Addendum 106: Regulation No. 107

Revision 3 – Amendment 4

Uniform provisions concerning the approval of category M₂ or M₃ vehicles with regard to their general construction

Model A

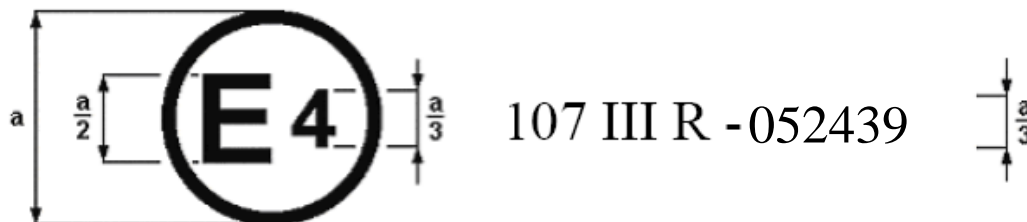
Annex 2, amend to read:

The above approval mark ... under approval number 052439. The approval number ... as amended by the 05 series of amendments.

Model B

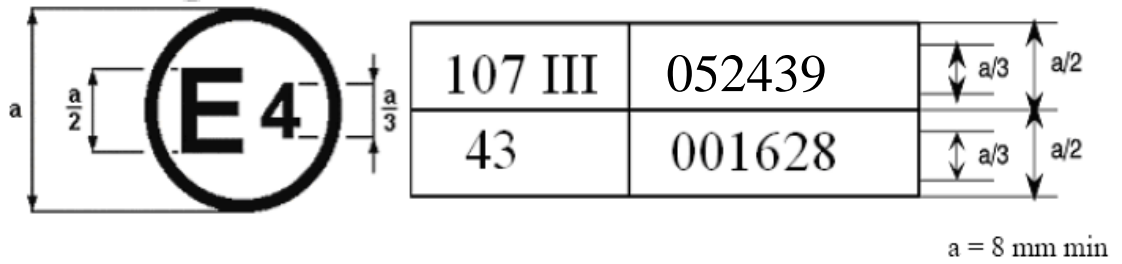
The above approval mark ... Regulation No. 107 included the 05 series of amendments and Regulation No. 43 was in its original form.
